ECE/TRANS/WP.29/GRE/2009/69
17 July 2009

REGULATION No. 48

Clarifications on installation requirements

Proposal for draft Supplement 5 to the 04 series of amendments to Regulation No. 48

Figure 1

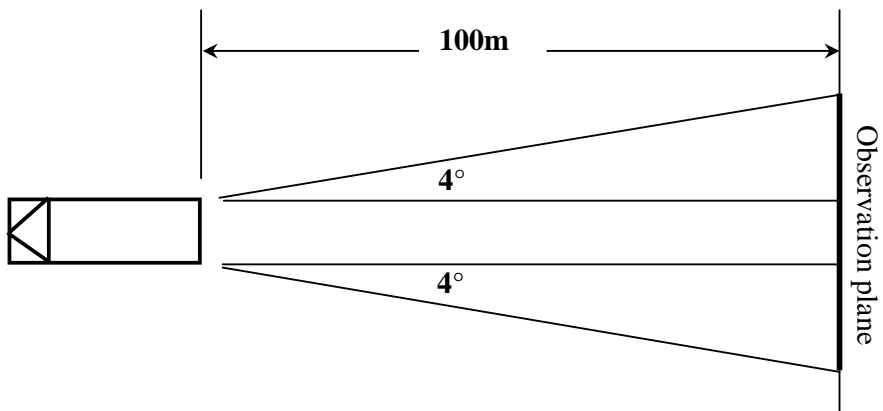
6.21.5.1. for rear conspicuity markings (see Annex 11, Figure 1) the observation plane is perpendicular to the longitudinal axis of the vehicle situated **100 m** from the extreme end of the vehicle and bounded by:

6.21.5.1.1. in height, by two horizontal planes 1 m and 3.0 m respectively above the ground,

6.21.5.1.2. in width, by two vertical planes which form an angle of **4°** outwards from the vehicle's median longitudinal plane and which pass through the intersection of the vertical planes parallel to the vehicle's median longitudinal plane delimiting the vehicle's overall width, and the plane perpendicular to the longitudinal axis of the vehicle that delimits the end of the vehicle.

Figure 2

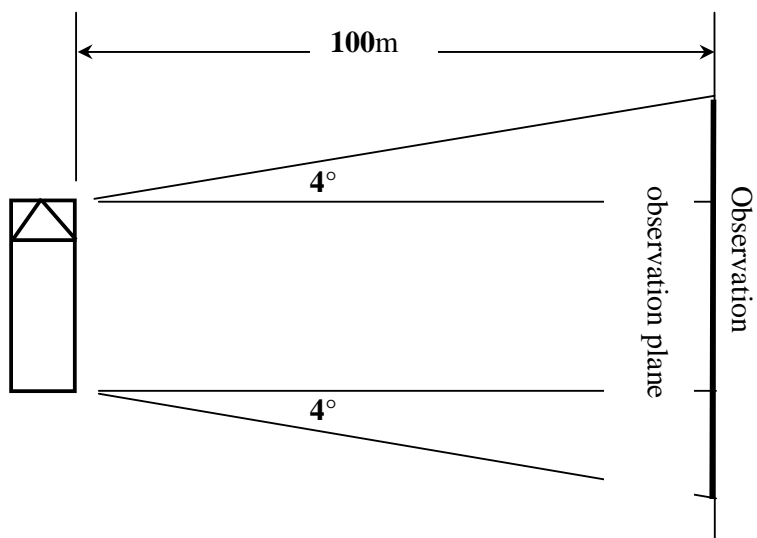
- 6.21.5.2. for side conspicuity markings (see Annex 11, figure 2) the observation plane is parallel to the longitudinal median plane of the vehicles situated **100** m from the extreme outer edge of the vehicle and bounded by:
- 6.21.5.2.1. in height, by two horizontal planes **1.0** m and 3.0 m respectively above the ground,
- 6.21.5.2.2. in width, by two vertical planes which form an angle of **4°** outwards from a plane perpendicular to the vehicle's longitudinal axis and which pass through the intersection of the vertical planes perpendicular to the vehicle's longitudinal axis delimiting the vehicle's overall length and the extreme outer edge of the vehicle."
